### Staff Report & Recommendation

### Historic Preservation Board

SUBJECT: HPB18-0198, **835 Alton Road.**

The applicant, CO1 835, LLC (Eric Kamhi), is requesting a Certificate of Appropriateness for the construction of a 1-story ground level addition and modifications to the north and west facades.

*Original west elevation permit plan, 14479*

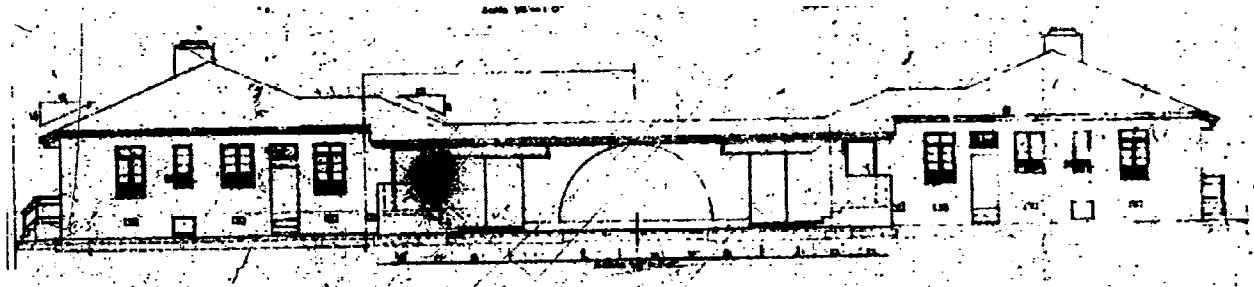
The applicant is proposing to construct an 875 square foot lobby located behind the existing covered entry feature along Alton Road. As part of the new lobby enclosure, glass doors with transoms are proposed within the existing open-air passageways and a new storefront window system is proposed within the open arch feature. Staff has no objection to the glazing system within these openings. However, staff recommends that the mullion configuration of the arched opening be further refined in a manner more consistent with the Med Deco style of architecture.

- c. The mullion configuration of the arched opening along Alton Road shall be further refined, in a manner to be reviewed and approved by staff consistent with the Certificate of Appropriateness Criteria and/or the directions from the Board.
